Subject: McGuire Nuclear Station
Docket Nos. 50-369 and 50-370
Response To Request For Additional Information
Regarding Duke's Request For Extended Outage Time
For The VC/YC System Modification (TACs 65649 and 65650)

ATTACHMENT
Duke Power Company
McGuire Nuclear Station
Response To Request For Additional Information

FIGURE 1

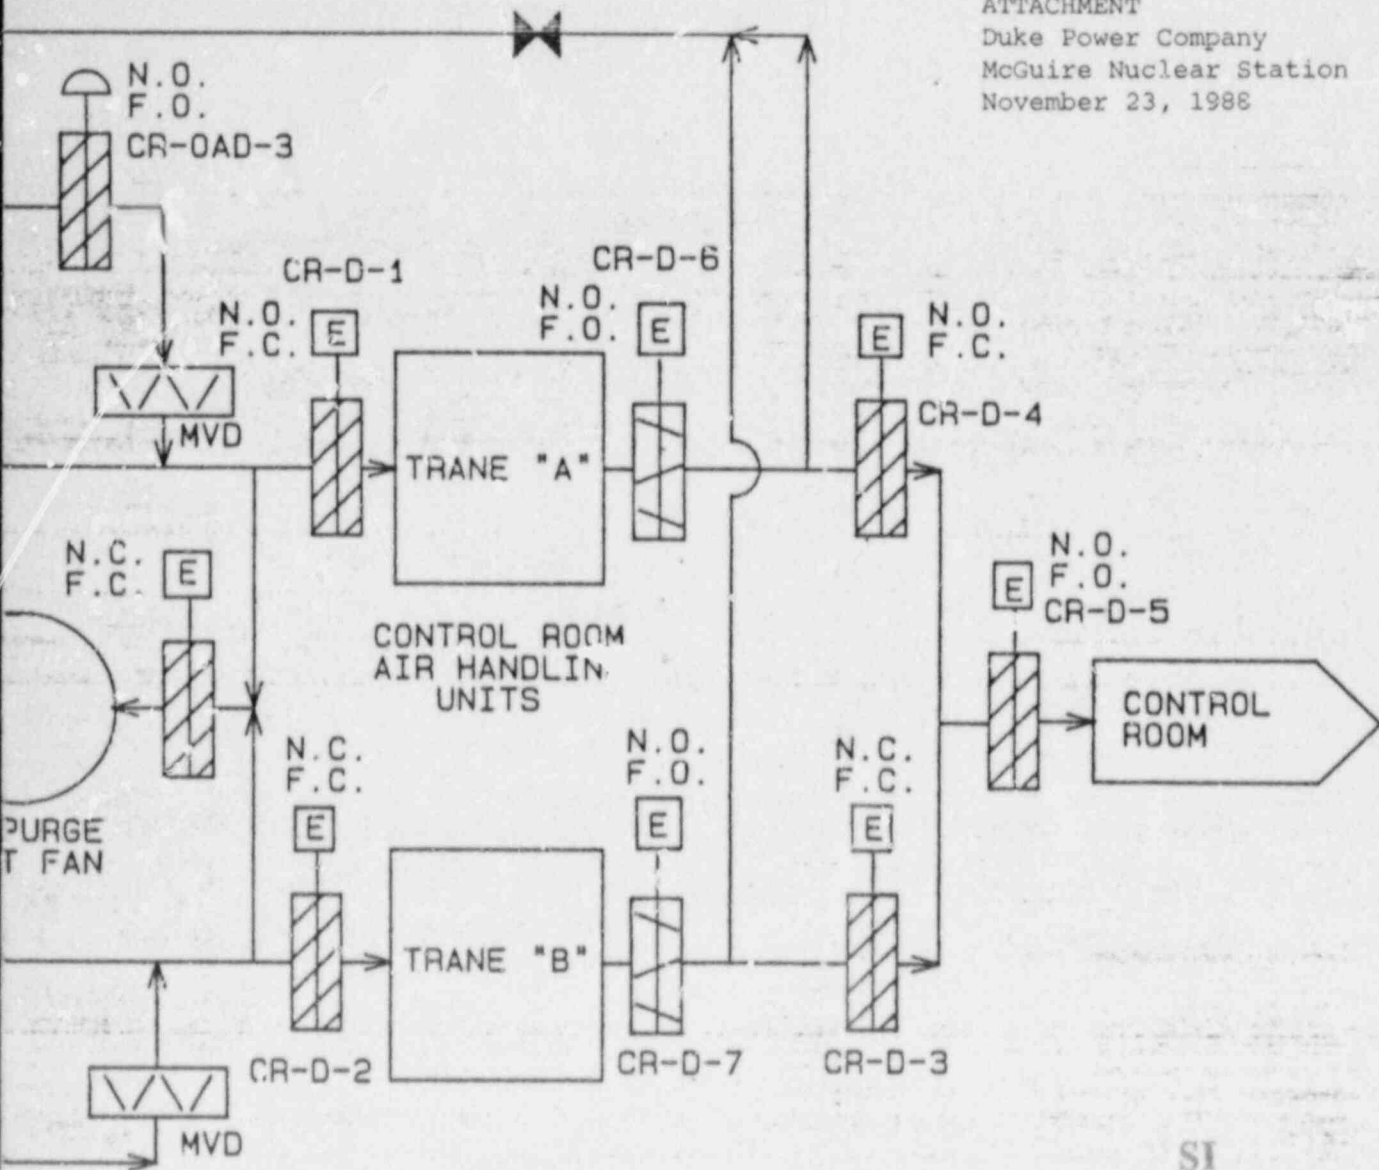
Discuss the controls for the VC system dampers. Justify the proposed change in terms of the potential for, and the consequences (i.e., personnel exposure) of, failure of the damper in the recirculation line which influences flow to the system filters. Include all failure modes (open, closed, partially closed). To what extent can damper failure affect operator doses due to lowered differential pressures (i.e., recirculation damper fails open) or increased flows (i.e., damper fails closed)?

The Control Room ventilation system (See attached partial VC flow diagram fig. 1) is one of several subsystems which make up the VC system. The ventilation system provides make-up air through four air vents at two locations on the Auxiliary building roof. Filtering capability is provided by two redundant pressure filter trains (OAPFT-1, and OAPFT-2).
